**Subject: Objection to planning application 2025/0664/P 13 Lambolle Road,
NW3 4HS**

We would like to strongly object to application 2025/0664/P for a Certificate of Lawfulness to build a gym/spa/office at 13 Lambolle Road, NW3 4HS.

Arboricultural Report

**51 Lancaster Grove
London
NW3 4HB**

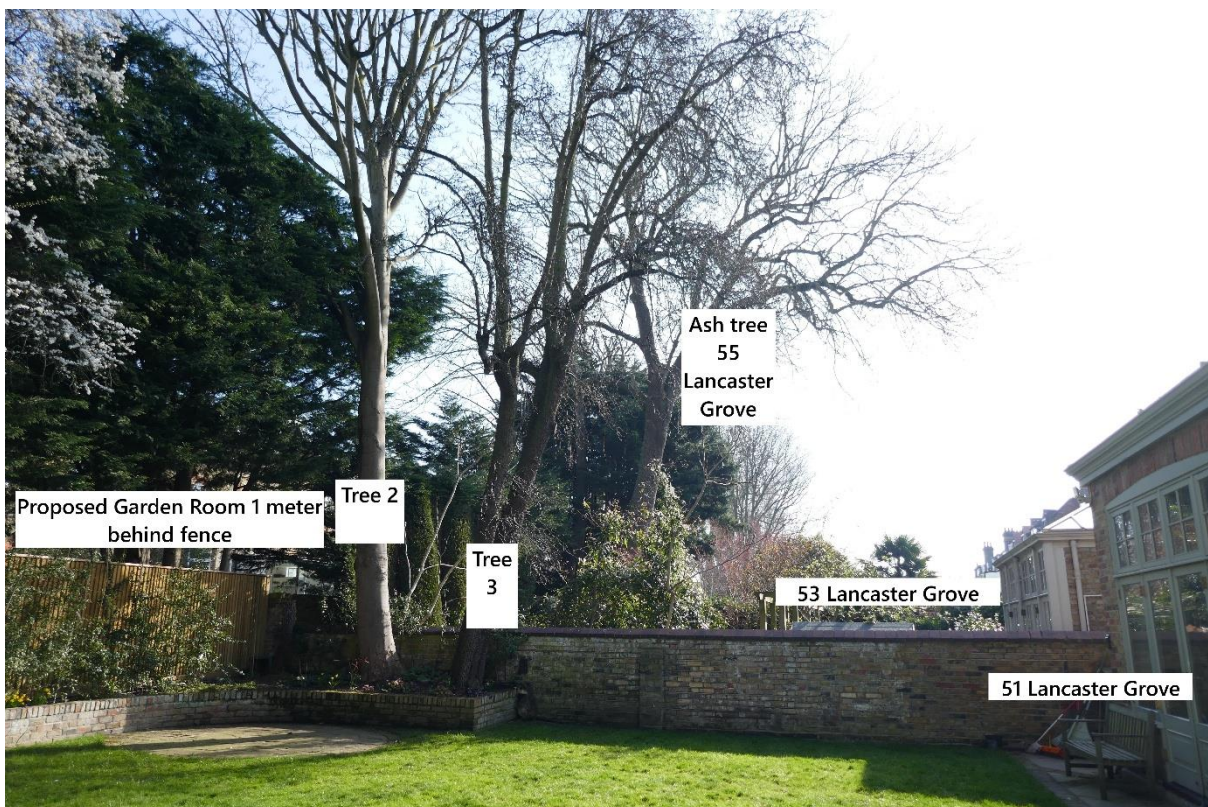
We have lived at 51 Lancaster Grove for 19 years. Our house backs immediately on to 13 Lambolle Road. We have 3 large, mature trees in our garden whose RPAs will be impacted by the proposed gym/spa/office.

Tree 1: Cherry plum, 9 meters high, mature, T15

Tree 2: Sycamore, 15.5 meters high, early mature, T9

Tree 3: Pear, 13.5 meters high, mature, T26 (not included in 13 Lambolle's tree survey but less than 5 meters from the proposed gym/spa/office as detailed in our AIA report)

Our pear and sycamore are less than 11 meters from our house and from 53 Lancaster Grove

2. Beech tree, around 10 meters tall, 15 Lambolle Road, 2-3 meters from the proposed development
3. Elder tree, around 5 meters tall, 5-9 Lambolle Road, 2-3 meters from the proposed development
4. Ash tree, around 20 meters tall, 55 Lancaster Grove (marked in photo above) 8-9 meters from the proposed development
